Subject: Quad-Cities Station Unit 1  
Proposed Amendment to License and  
Appendix A, Technical Specifications,  
for Facility Operating License DPR-29  
to Support Reload No. 4  
NRC Docket No. 50-254

ENCLOSURE I

QUAD-CITIES UNIT 1

NRC DOCKET NO. 50-254

MAXIMUM AVERAGE PLANAR LINEAR  
HEAT GENERATION RATE (MAPLHGR)  
VS. PLANAR AVERAGE EXPOSURE

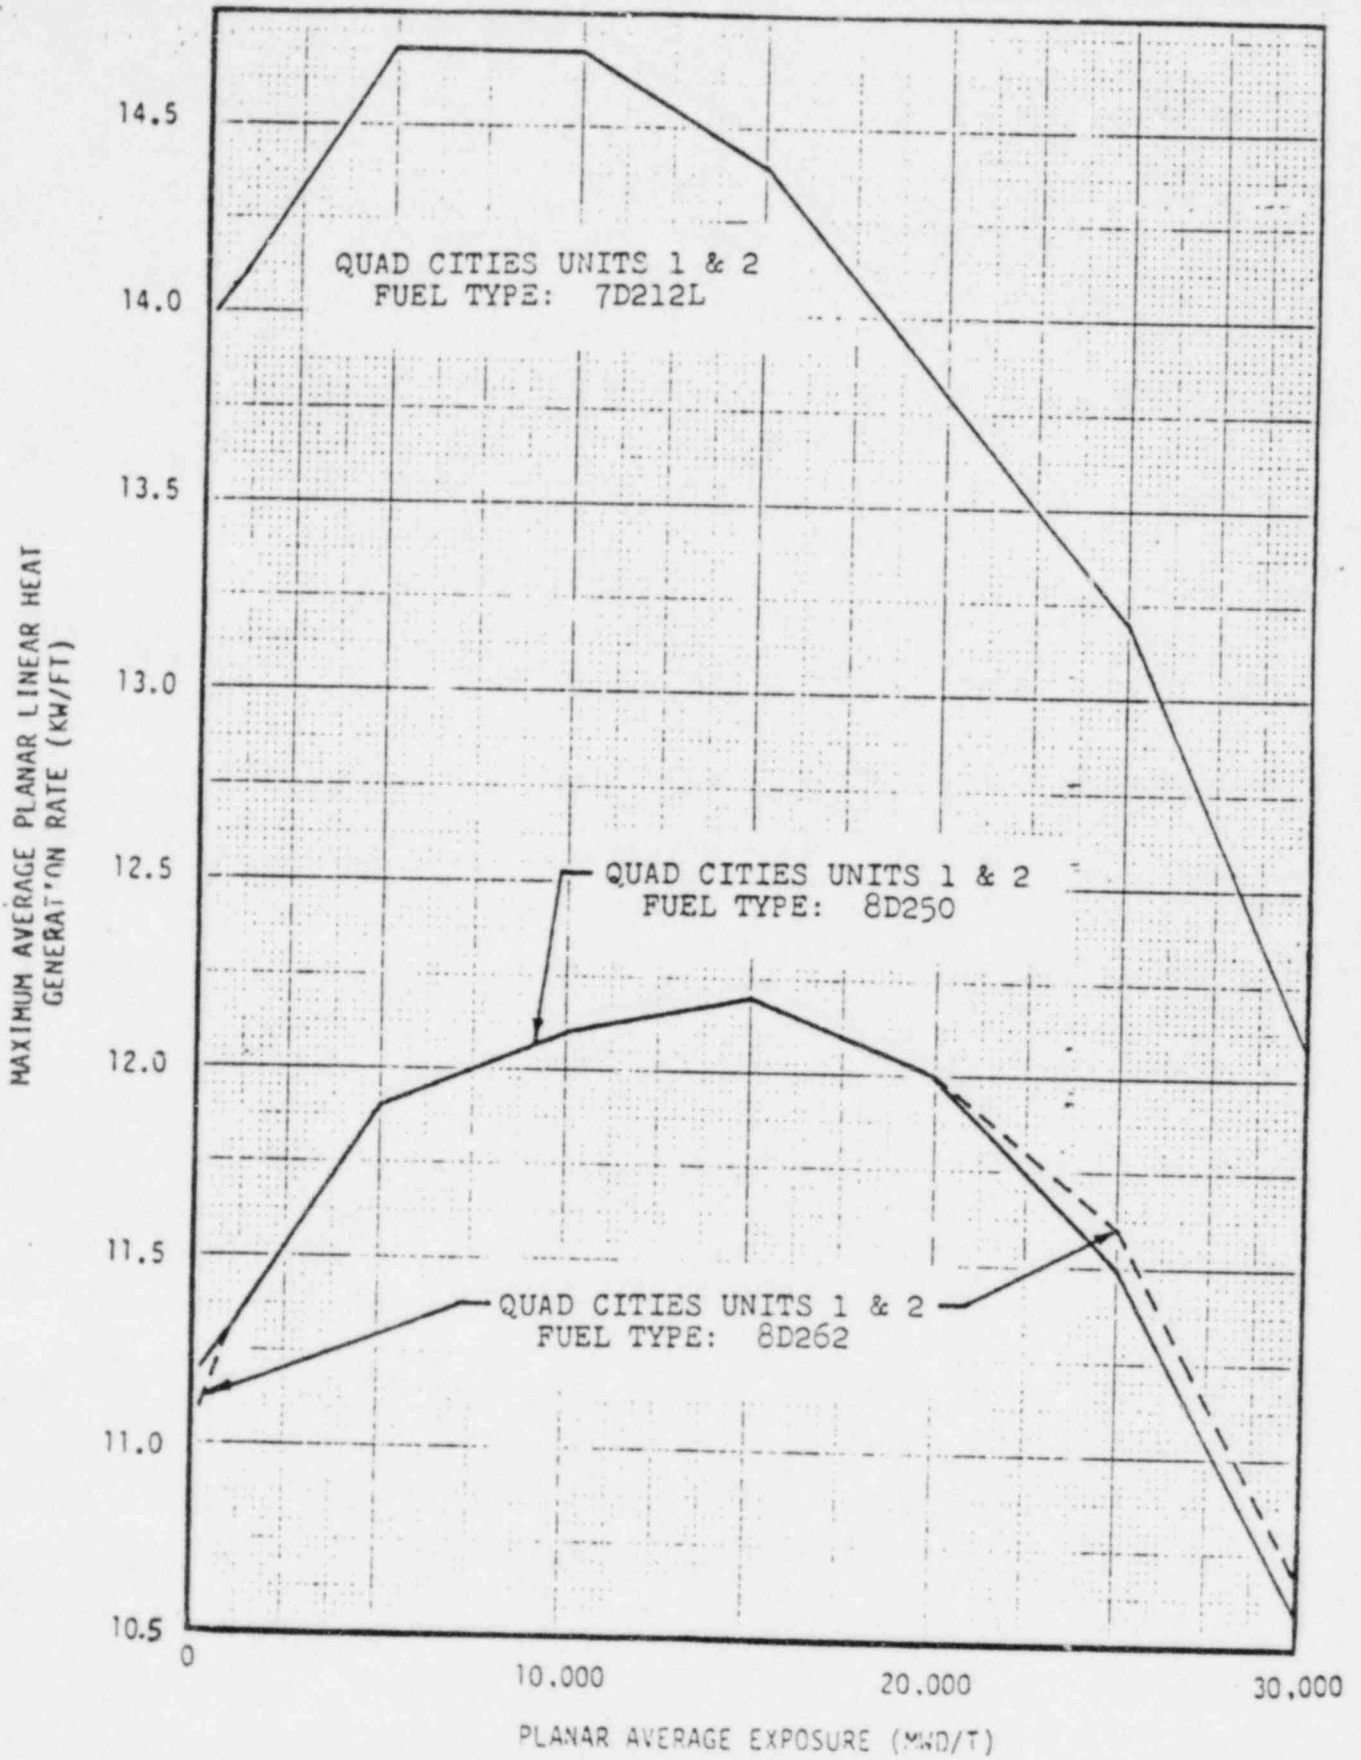
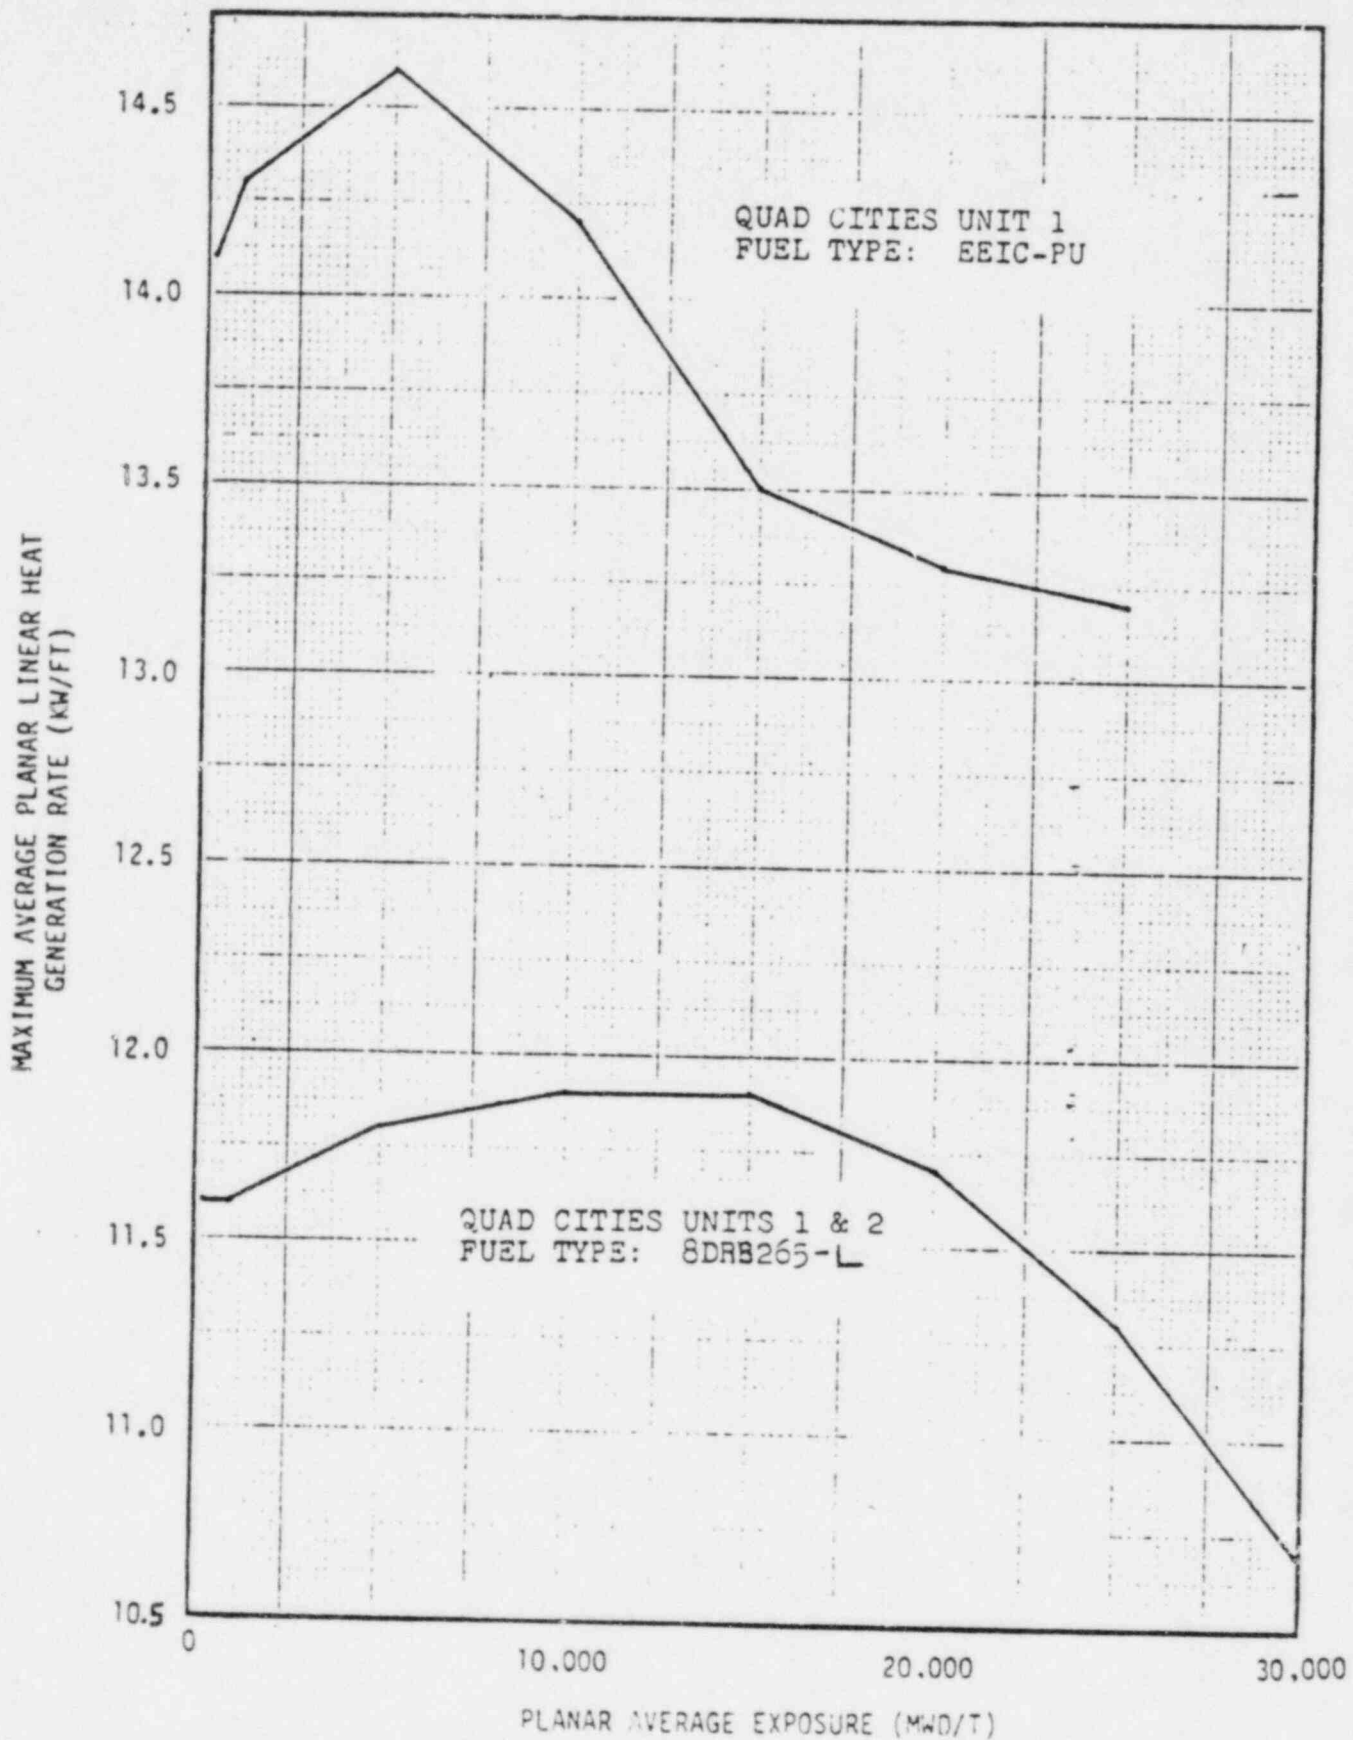
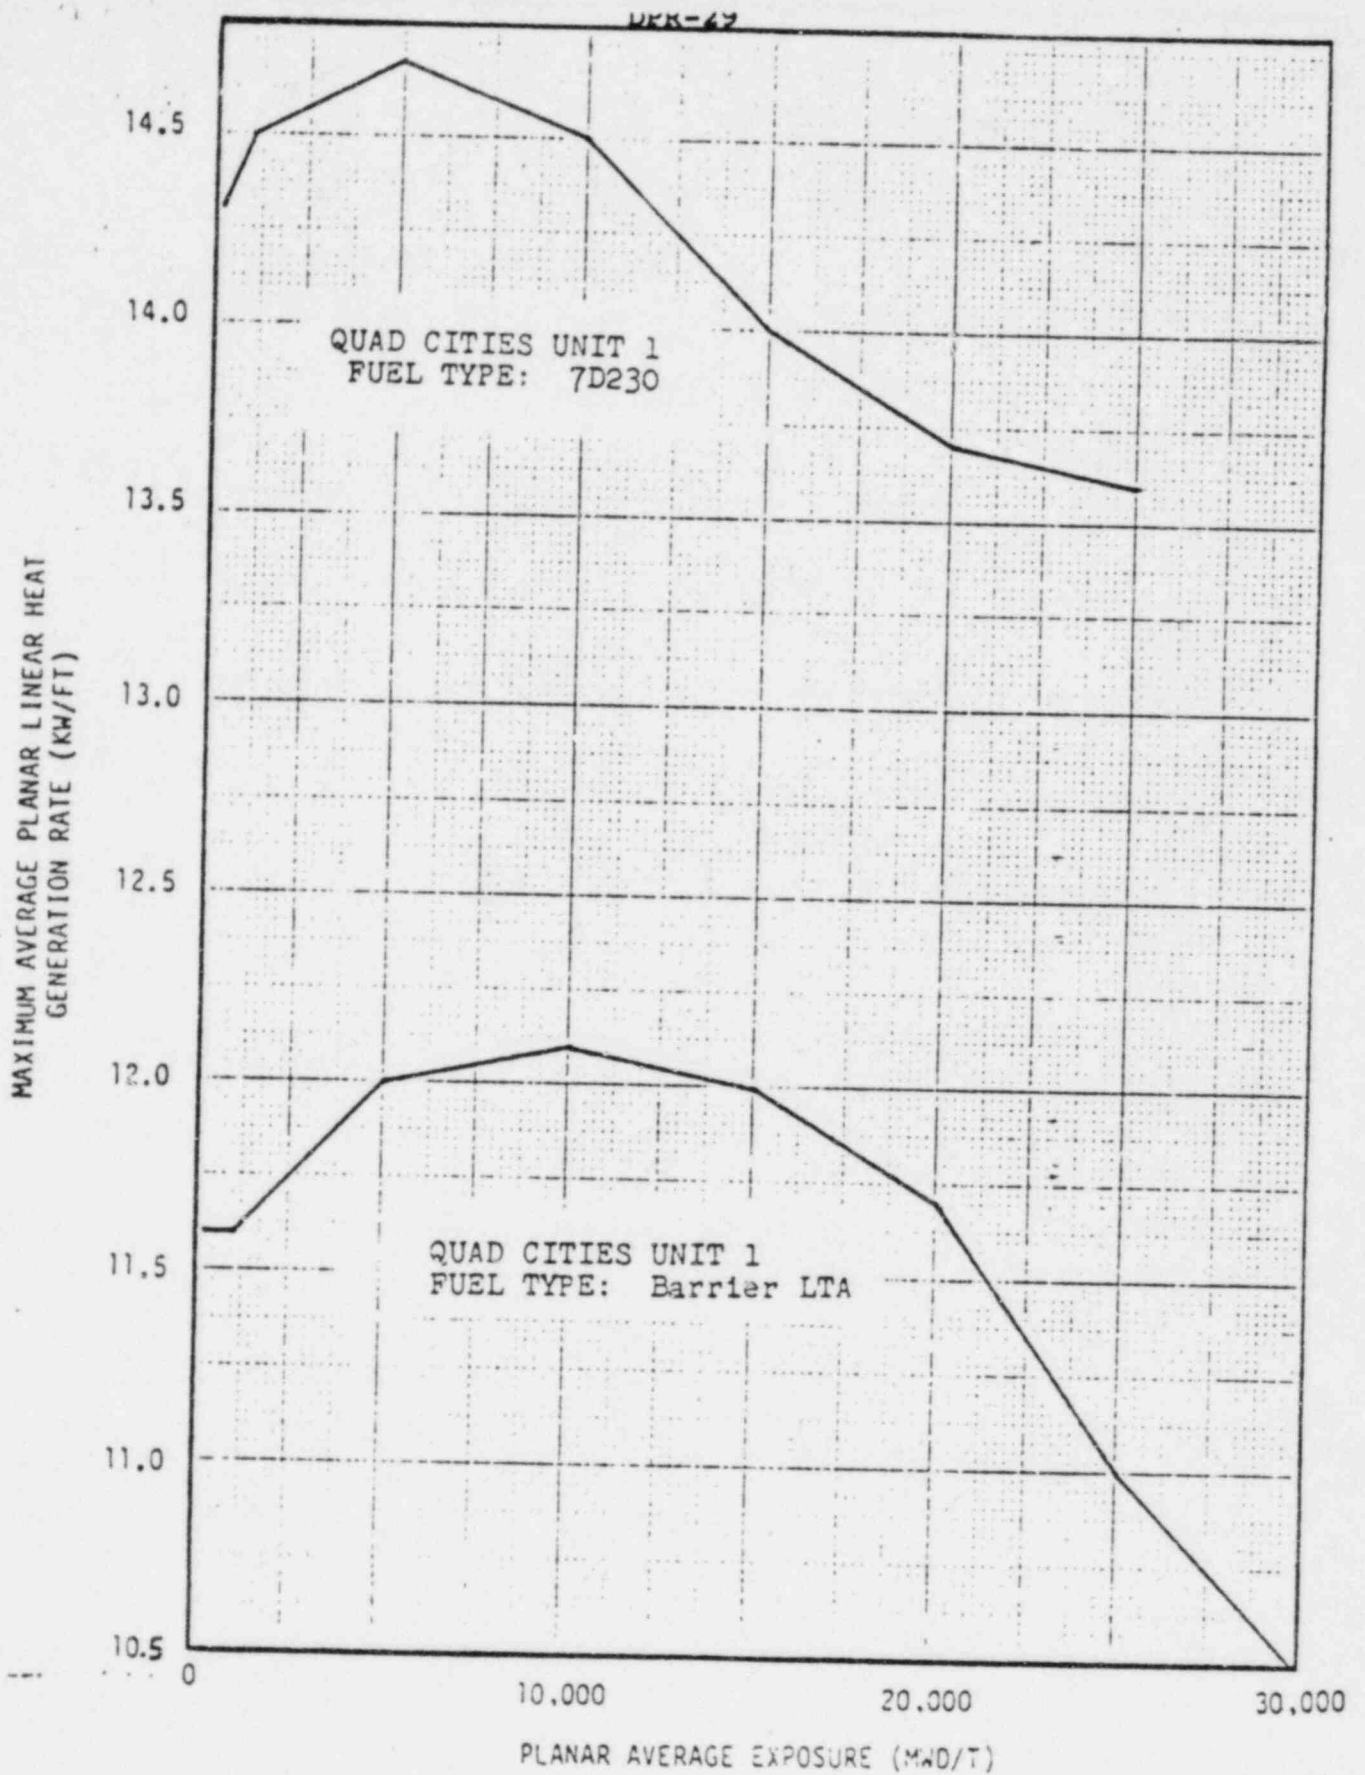
A reanalysis of ECCS performance (Enclosure IV) for the limiting break size LOCA has resulted in relaxed MAPLHGR limits primarily due to the effects of drilled lower tie plates in the retrofit and BLTA reload fuel. The most notable feature of the new analysis is the utilization of Duane Arnold as the lead plant for several BWR 3's with loop selection logic. This approach allows units with similar ECCS characteristics to reference the full break spectrum analysis of the lead plant and necessitates detailed calculations for the limiting break size only (in this case the DBA value of 4.18 ft.<sup>2</sup>).

Although the increase enrichment in the central axial fuel zone is expected to increase operating MAPLHGR values, margin to limits is expected to improve since the LOCA analysis, incorporating the effects of drilled lower tie plates, increases the MAPLHGR limits proportionally greater than the expected increase in operating MAPLHGR values.
